Response to the Referee #2

First review of “Simultaneous retrievals of biomass-burning aerosols and trace gases from the ultraviolet to near-infrared over northern Thailand during the 2019 pre-monsoon season” by Jeong et al. (April 11, 2022)

Reviewer Recommendation: Requires major revisions before publication

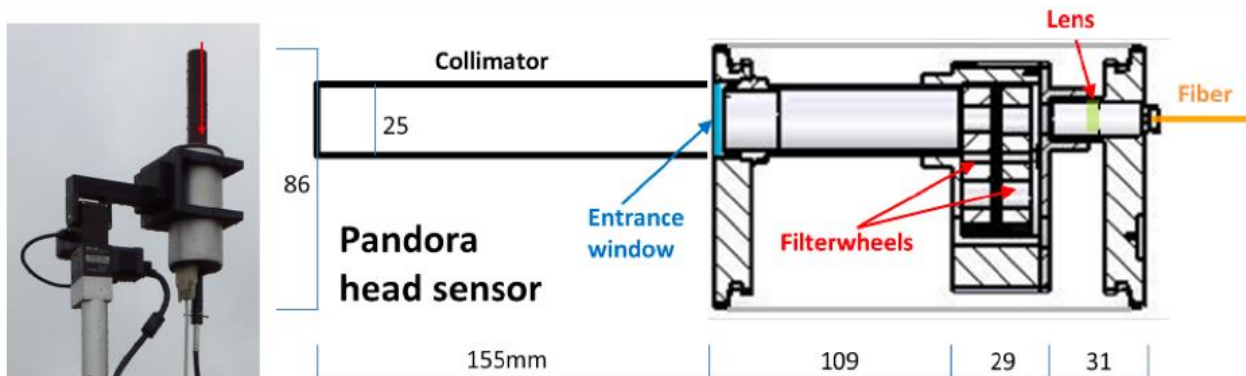
13. Lines 213-215: Is this a mistake that inserting the diffuser alters the instrument field of view? Does the diffuser have optical power (i.e. does it have a focal length smaller than infinity)? I am assuming the field stop is the optical fiber that transfers light from the scanning head to the spectrometer, which I am also assuming doesn't change with or without the diffuser. I could easily believe that the diffuser acts as an aperture stop but that seems weird that it would alter the field of view.

→ The diffuser was added to improve the quality of the direct sun measurements, so the light is distributed homogeneously on the surface of the fiber (this is why the diffuser is only used for the sun measurements, not the sky), no angular effects and mostly flat FOV top. The FOVs for different filters (open, diffuser, etc) are measured by scanning solar aureole angles with a 0.1° resolution). See the below figure for more details about the sensor head.
